LEXINGTON-FAYETTE URBAN COUNTY GOVERNMENT CONTRACT CHANGE ORDER Page 1 of 2		Date:	November 9, 2015	
		Project:	Senior Citizen Center Construction	
		Location:	Lexington	
To (Contractor): Marrillia Design & Construction 259 West Short Street Suite 325 Lexington, KY 40507		Contract No.	227-2014	
		Original Contract Amt.	\$8,882,900.00	
		Cumulative Amount of Previous Change Orders	\$1,300,831.24	
		Percent Change - Previous Change Orders		14.64%
		Total Contract Amount Prior to this Change Order	\$10,183,731.24	
		Change Order No.	26	
		You are hereby requested to comply with the following changes from the contract plans and specification;		
Current Change Order

CHANGE ORDER NO. 26

PROJECT	LFUCG Senior Citizens' Center 201333	DATE SENT	9/23/2015
SUBJECT	Revise Pole Light Configuration	PROPOSAL REQUEST ID	PR-034
TYPE	Proposal Request	TRANSMITTAL ID	00649
PURPOSE	For Review and Response	VIA	Info Exchange

SITE LIGHTING CHANGE- SKETCH #1

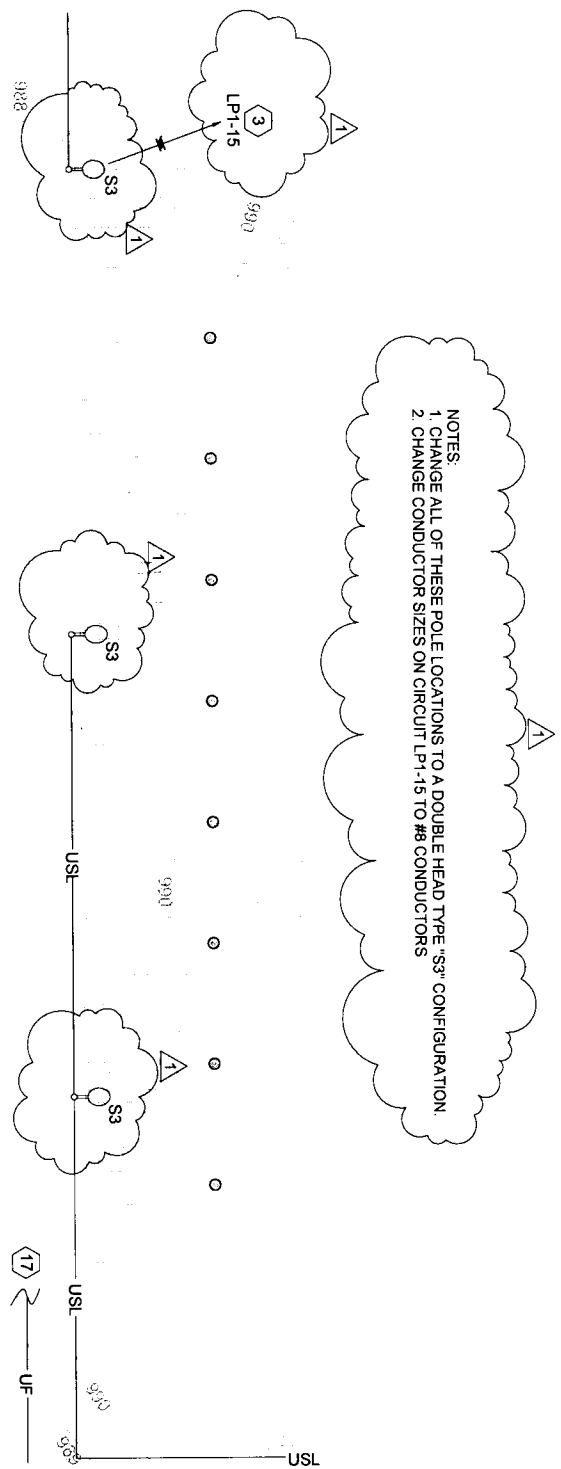
Please provide pricing to revise pole lights indicated in the attached sketches to two-head fixtures. Fixture, pole, and head type and finish to be same as previously approved. As an add alternate to the base price, please provide (1) pole light as described in the attached cut sheet and shown on attached sketch.

SKE-11.1

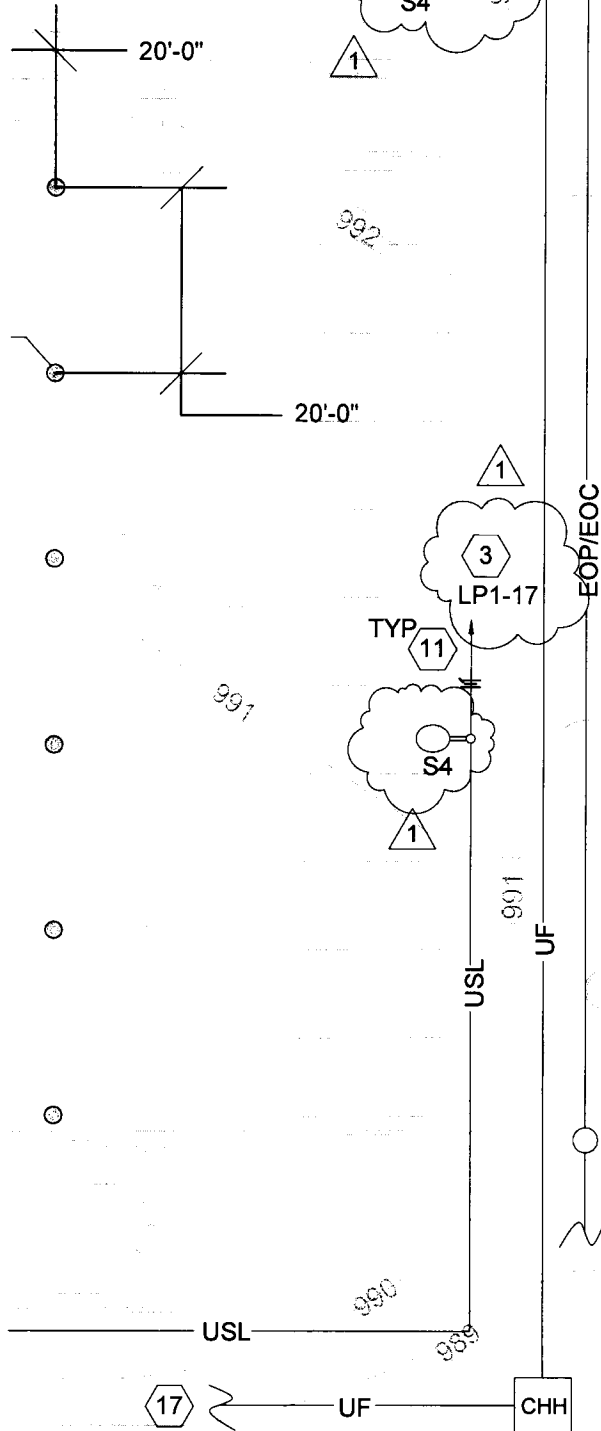
1. CHANGE ALL OF THESE POLE LOCATIONS TO A DOUBLE HEAD TYPE "S4" CONFIGURATION.
2. SPLIT CIRCUIT LP1-17. FEED TWO POLES FROM CIRCUIT #17 AND THE LAST POLE FROM CIRCUIT LP1-19. CONDUCTORS SHALL BE #8 FOR ALL CIRCUITS.

SKE-11.2

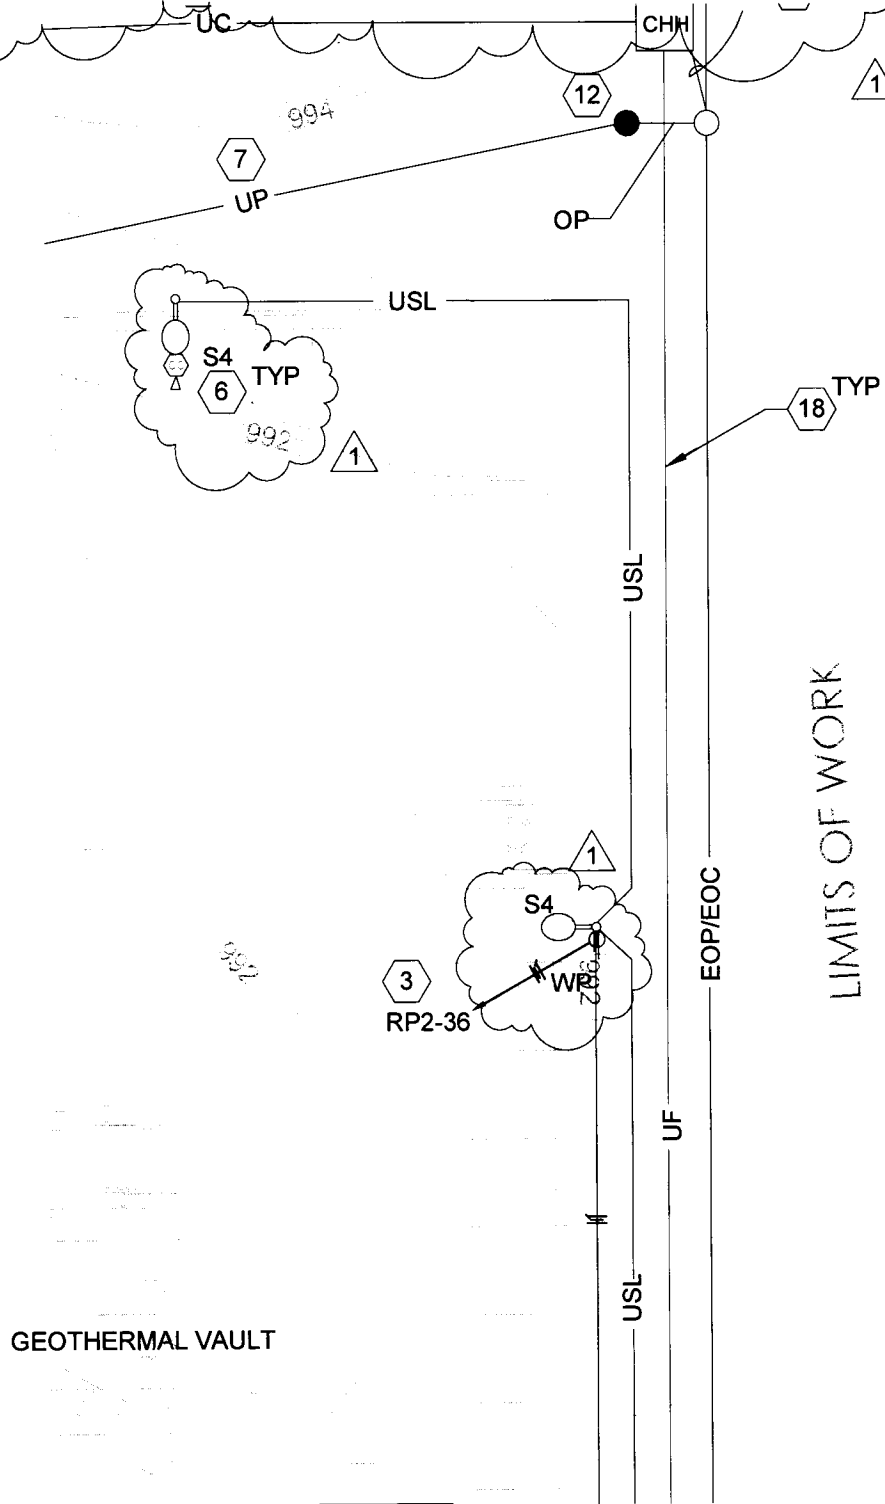
1. CHANGE ALL OF THESE POLE LOCATIONS TO A DOUBLE HEAD TYPE "S4" CONFIGURATION.

2. SPLIT CIRCUIT LP1-13. FEED TWO POLES FROM CIRCUIT #17 AND THE THESE TWO (2) POLES FROM CIRCUIT LP1-21. CONDUCTORS SHALL BE #8 FOR ALL CIRCUITS.
